JOINT STATEMENT OF FLOOD AND EROSION EXPERTS

Project title Brookside Development

Subject Brookside Development Stream Bank Protection

Annex 2 – Marked up Drawing Providing Agreed Extents of Erosion Protection

Figure 9 Recommended limiting values for erosion resistance of plain and reinforced grass

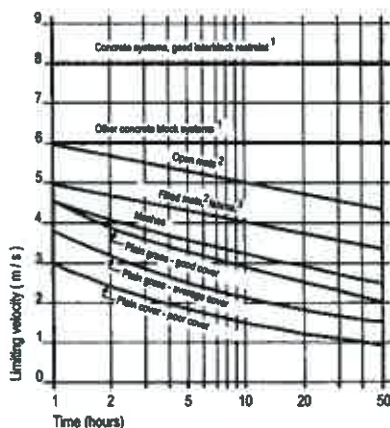
Item	Text	Action on
1	<p>Discussed the current discrepancy in the recommended stream bank / channel protection highlighted in the Mott MacDonald March 2016 peer review and the proposed stream bank / channel protection in the Cardno July 2015 Flood and Erosion Hazard Assessment Report. TJ pointed out that the review simply highlighted the discrepancy in the July 2015 report which states <i>"In areas where the velocity is less than 2.2 m/s then the proposed vegetation on the side slopes will be capable of withstanding erosion from the flow. Where the velocity is greater than 2.2 m/s rock protection which is capable of withstanding the velocity will be placed to restrict migration of the creek. The extent of rock protection required within the channel and side slopes within Duck Creek has been determined based on the flow velocity within the 10 year event."</i> (http://www.qw.govt.nz/assets/Resource-Consents/Duck-Creek-North/Consent-Application-Documents/Appendix-9-Flood-and-Erosion-Hazard-Assessment.pdf#page=16).</p> <p>Although the report states a 2.2 m/s velocity criteria for the 10 year event was used for bank / channel protection selection KC explained that this was only the starting point for the assessment and that a more detailed description of the methodology had been provided in evidence and the presentation (attached) on the first day of the hearing. The bank / channel protection selection was based on:</p> <ul style="list-style-type: none"> The figure shown below from the CIRIA (construction industry research and information association) Report 116: Design of Reinforced Grass Waterways 2.7 m/s velocity criteria for the 10 year event, Best engineering judgement and experience from Mr Christensen building on the same methodology that was used on the steeper upstream reach (Duck Creek South) which has performed in notable events (>10yr return period – 14 May 2015). 	No Action

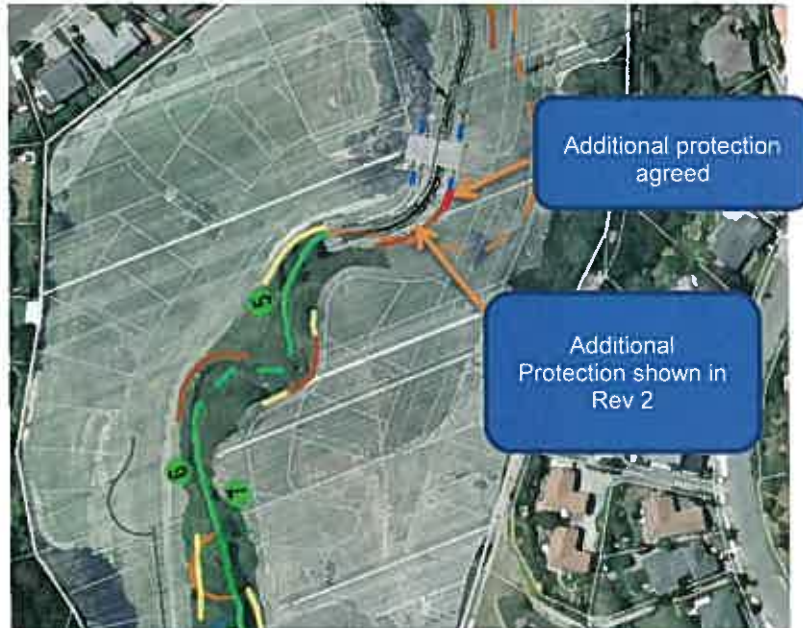
- 4 It was identified that TJ was working with an out of date plan (Drawing 115065-PL-C251 Rev 1 03/07/15) a later version (Rev 2 - 25/08/15) has some additional bank / channel protection which has eliminated one area of the discrepancy. Specifically an area upstream of Bridge 3 as described in the figure below. In addition a small section of additional protection on the right bank just upstream of the bridge was agreed to be added by KC. This is also shown in the figure below.

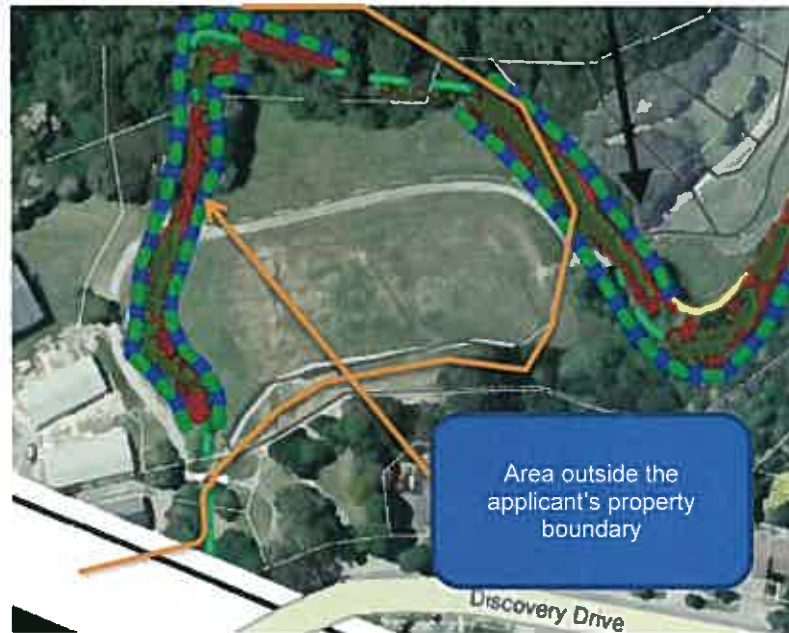
TJ agreed that the Mott MacDonald report highlighted potential issues that are outside of the applicant's property boundary where there were no effects associated with the proposed development and therefore the applicant would have little control or requirement to undertake works. This was highlighted in the review for completeness and possibly could have been picked up as an effect of the Duck Creek South development. Given that we are currently discussing only the Duck Creek North development TJ has accepted that this area should be removed from the current recommendation. However it should be noted by PCC as a potential area where further investigation may be required. KC noted that much of this area has been stable for the past decade and has mature vegetation on the banks however could not comment on the erosion potential immediately downstream of the Discovery Drive Culvert

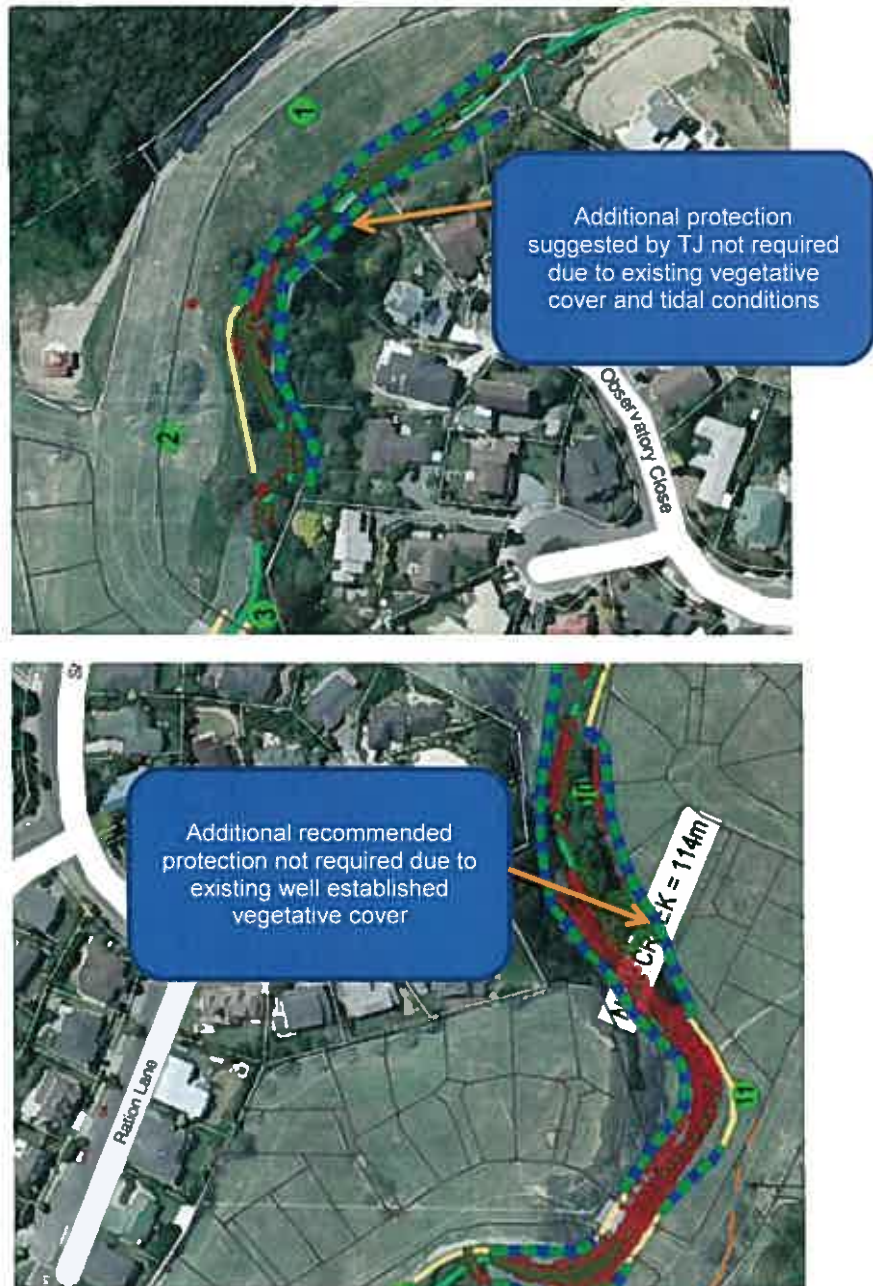
- 6 KC agreed to investigate additional stream bank / channel protection upstream of Bridge 2 to protect the fill face and tie in with the bridge rock work. KC

- 7 Following a site visit TJ concluded that two areas where he had previously recommended additional protection are likely not required due to very flat tidal conditions with little evidence of existing erosion and well established existing vegetative cover. It will however be essential to ensure that the riparian vegetation in these areas is re-established as rapidly as possible to minimise erosion risk on bare soil with high velocity potential predicted. KC noted that riparian restoration planting is proposed throughout this reach. TJ
